Technical Document LA21018

Part 2 – Technical Requirements

Application under the *Agricultural Operation Practices Act* for a confined feeding operation, manure collection area and/or manure storage facility(ies)

NRCB USE ONLY	Application number	Legal land description
<input checked="" type="checkbox"/> Approval <input type="checkbox"/> Registration <input type="checkbox"/> Authorization <input type="checkbox"/> Amendment	LA21018	SW 11-15-18 W4M

FIGURE 2

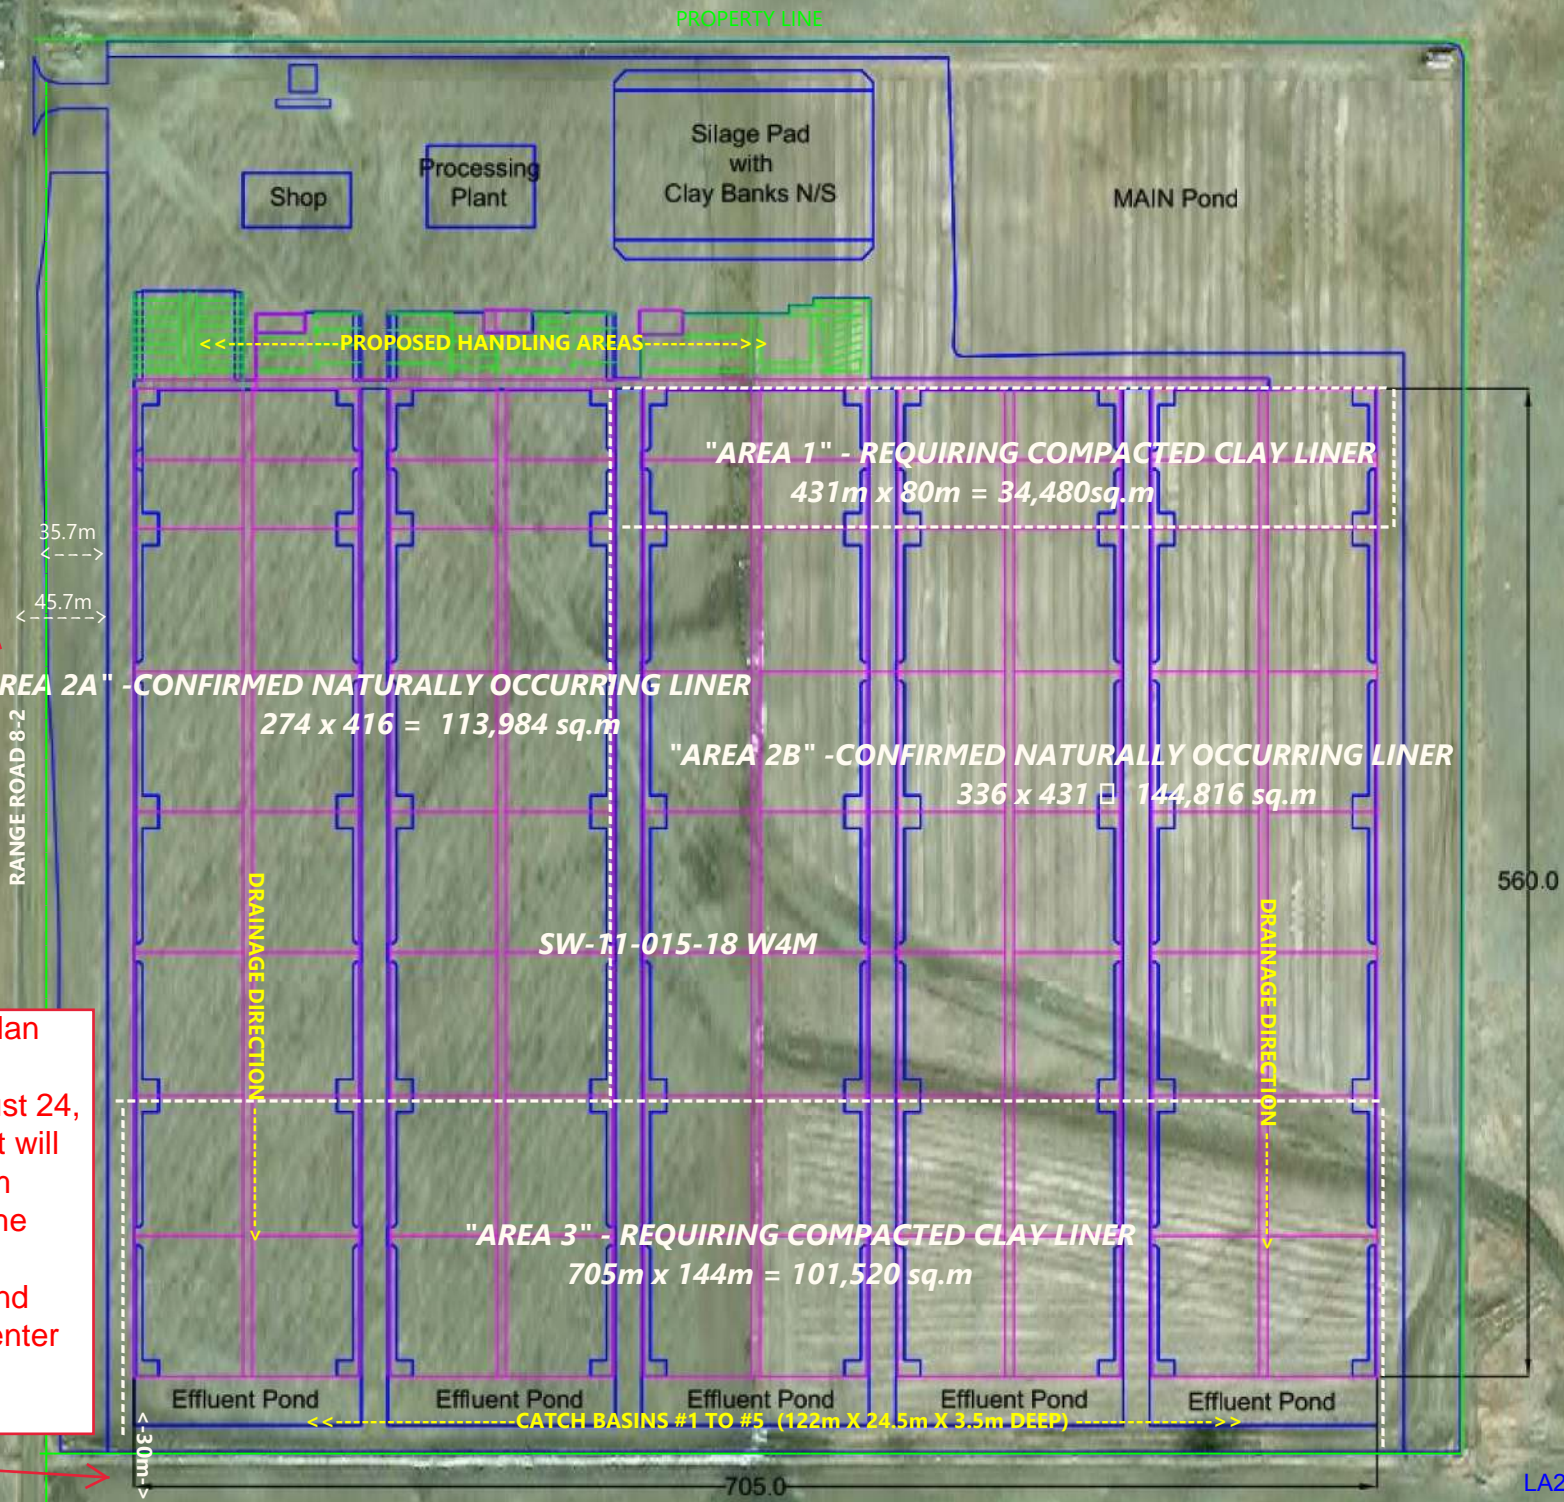
Updated site plan submitted by applicant August 24, 2021 to show it will meet the 30 m setback from the side and rear property line and 45.7 m from center of roadway.

Figure 1

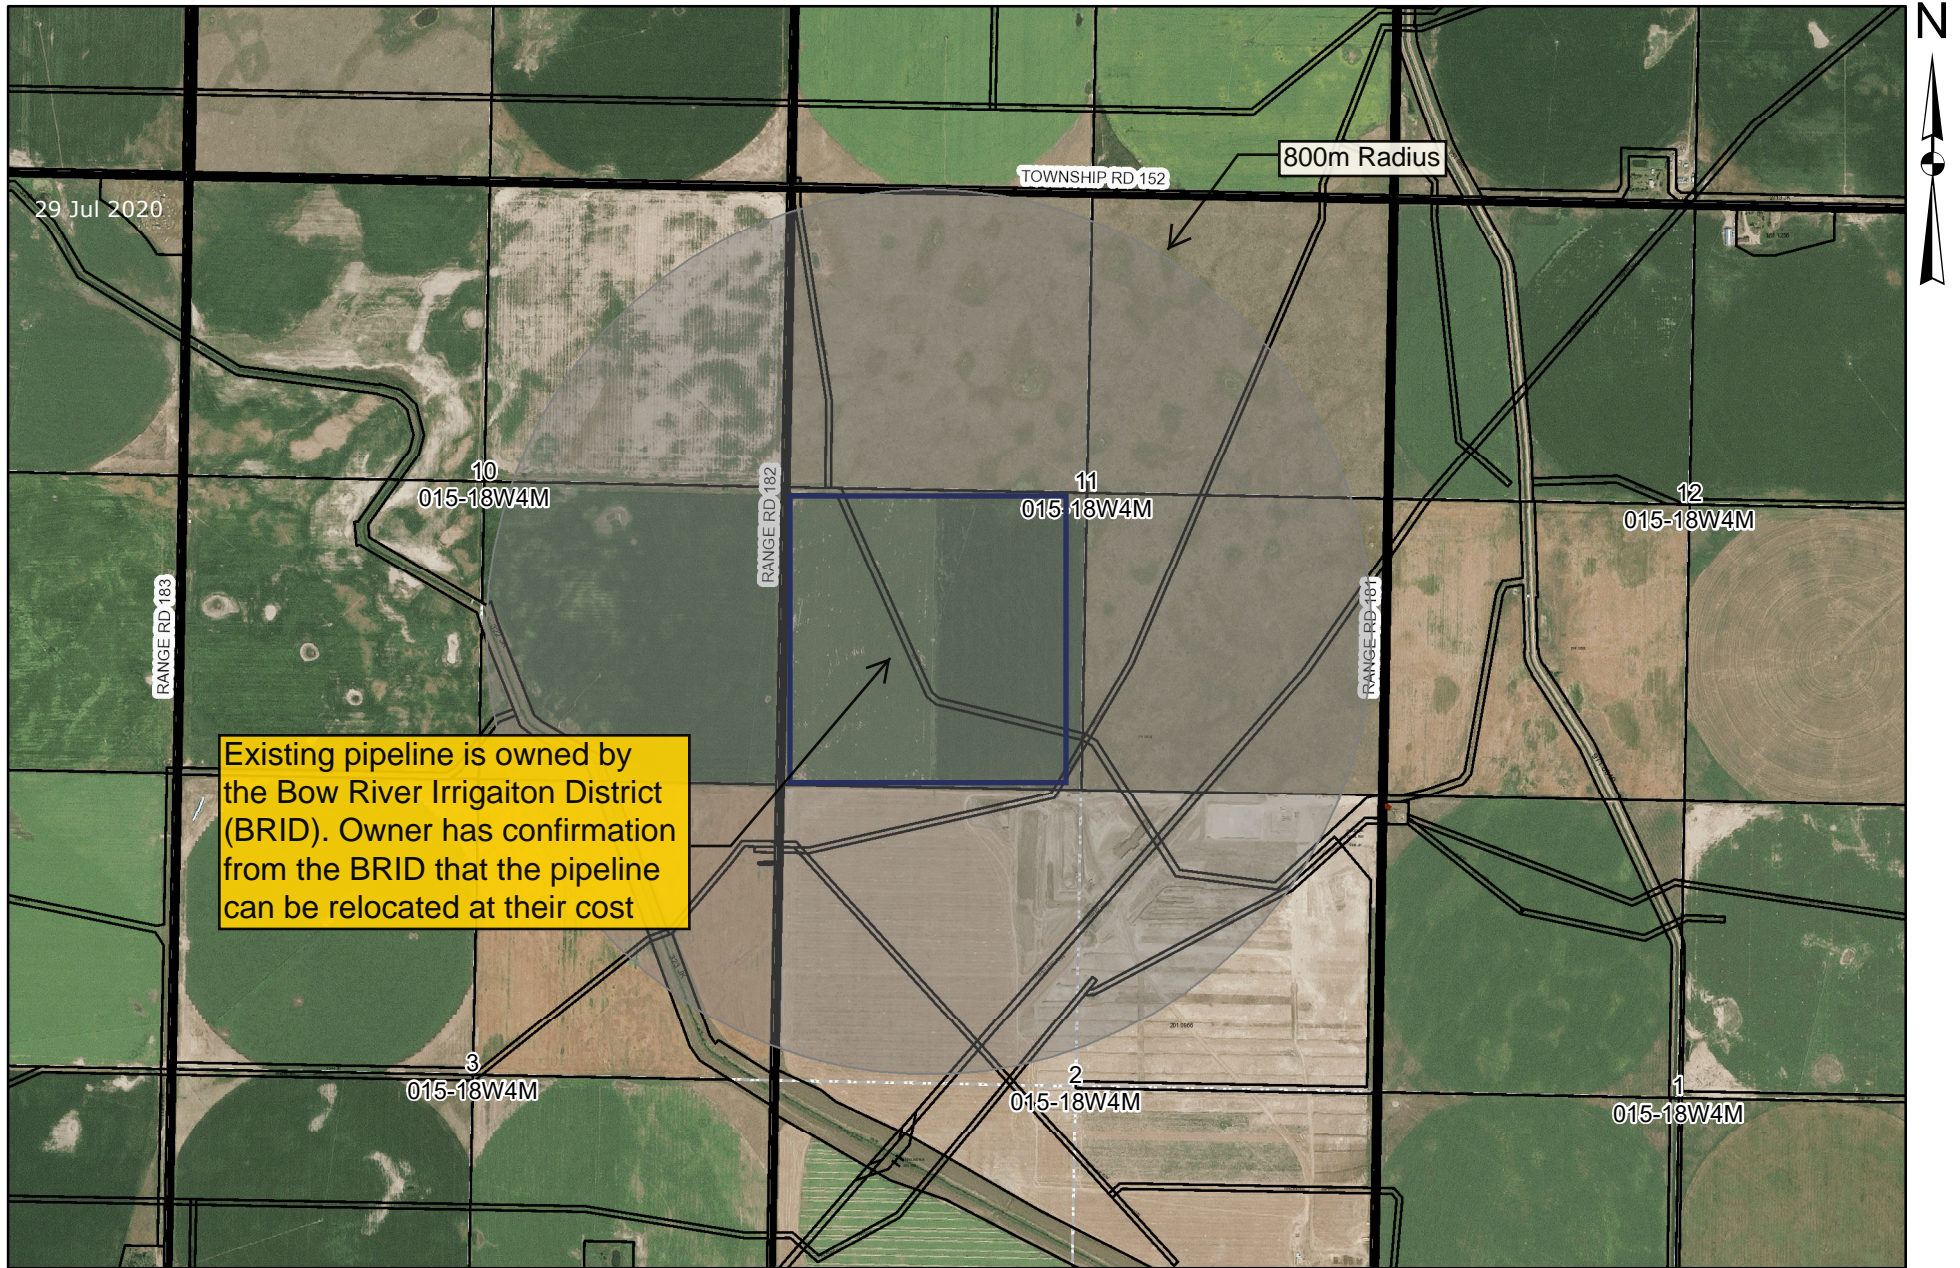
Existing pipeline is owned by the Bow River Irrigation District (BRID). Owner has confirmation from the BRID that the pipeline can be relocated at their cost

AO comments: applicant is responsible for any costs associated with relocating any pipelines
